# Access Compliance Report

## Public Rights-of-Way

### (Curb Ramps)

Intersection ID: N/A	Main Street: INVERNESS_BAY_RD	Cross Street: PERTH_MOOR_RD	Location: SW
ADA ID: A15D36B1BBAF	Ramp Type: Perp	Initial Pass/Fail: Fail	Overall Compliance: No
Codes/Mitigation Info/Possible Solution		Field Measurements/Component Compliance	
Severity Score: 25

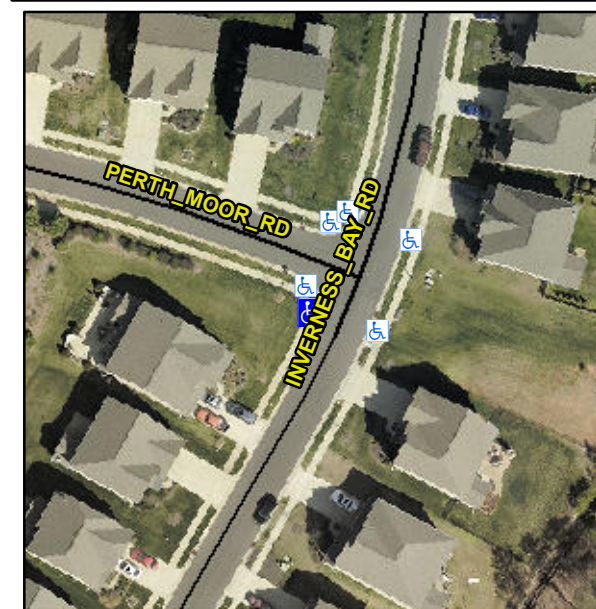
**Not Found, R304.2.2, R304.5.3**

Compliance	Description	Data	Compliance	Description	Data
N/A	Ramp Length (in)	47.0	No	Ramp Slope (%)	11.9
Yes	Ramp Width (in)	48.0	No	Ramp XSlope (%)	5.7
N/A	Flare Type LT	N/A	N/A	Flare Type RT	N/A
N/A	Flare Slope LT (%)	N/A	N/A	Flare Slope RT (%)	N/A
N/A	Flare Traversable LT?	N/A	N/A	Flare Traversable RT?	N/A
N/A	Landing Length (in)	N/A	N/A	DWS Provided?	N/A
N/A	Landing Width (in)	N/A	N/A	DWS Contrast?	N/A
N/A	Landing Slope (%)	N/A	N/A	DWS Length (in)	N/A
N/A	Landing X Slope (%)	N/A	N/A	DWS Full Width?	N/A
N/A	Landing Curb? (Y/N)	N/A	N/A	DWS Offset (in)	N/A
N/A	Shared Landing?	N/A			
N/A	Gutter Ponding?	N/A	N/A	Gutter Slope (%)	N/A
N/A	Gutter Lip Ht (in)	1.5	N/A	Gutter X Slope (%)	N/A
N/A	Painted X Walk1?	No	N/A	Painted X Walk2?	N/A
	X Walk 1 Direction	To SE		X Walk 2 Direction	N/A
N/A	X Walk 1 Width (in)	N/A	N/A	X Walk 2 Width (in)	N/A
	X Walk 1 Slope (%)	3.3		X Walk 2 Slope (%)	N/A
	X Walk 1 X Slope (%)	4.8		X Walk 2 X Slope (%)	N/A

**Remove & Replace Entire Ramp.**
